PCN-148076

Product Change Notice

Change of manufacturer location, change of product packing

AFBR-S4N66C013

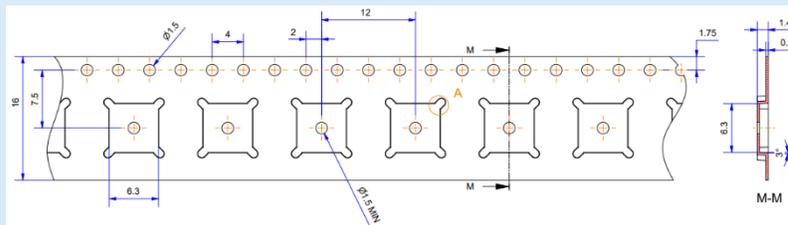
1. Activate additional manufacturing location.
2. Change product packing from waffle packing to reel packing:

Dimensions For Assembled EcoReel (All dimensions in mm)						
Tape Width	A (Diameter)	C	D (min)	N Hub	W1	W2 (max)
12	178 +/-1.0	13.5 +/-0.5	20.2	60 +0.1/-0.0	13 +/-0.5	15.5
All Other Dimensions and Tolerances are Fully Compliant With EIA 481-E

Each tape and reel contains 500 units.
